PROJECT NAME: **WAT BUDDHANIMIT, TONYKING RUANGSENA**
 PROJECT SITE ADDRESS: **7525 FALCON MEADOW BLVD
 FALCON, CO 80831 (EL PASO)**
 BUILDING SIZE: **36' x 72' x 15' 4" & 24' x 12' x 15' 4" & 24' x 2' x 15' 4" & 16' x 8' x 13' 4"**
 SHEET NAME: **SITE PLAN**

PROJECT NUMBER: **2022101267**
 SHEET NUMBER: **100**
 SHEET SCALE: **1/32"=1'-0"**

PCD File No.: PPR2416

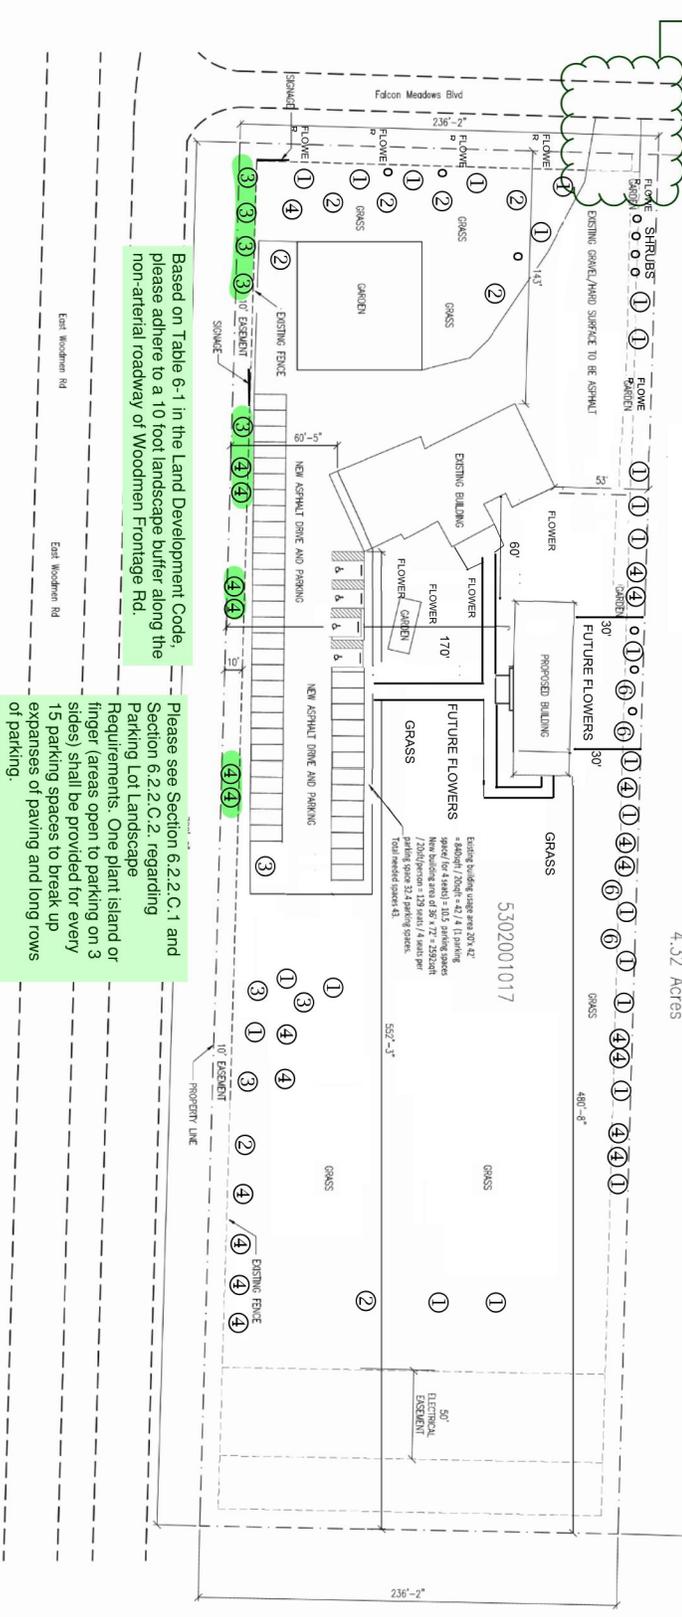
Please indicate sight distance triangles for the entrance/exit point into the property

Please depict the location of utilities

Please indicate the lot coverage calculation (what percent of the lot is covered by structures)

Please indicate the open space, landscaping, and impermeable surface percentages.

Based on Table 6-1 in the Land Development Code, please adhere to a 10 foot landscape buffer along the non-arterial roadway of Woodmen Frontage Rd.

Please see Section 6.2.2.C.1 and Section 6.2.2.C.2, regarding Parking Lot Landscape Requirements. One plant island or finger (areas open to parking on 3 sides) shall be provided for every 15 parking spaces to break up expanses of paving and long rows of parking.
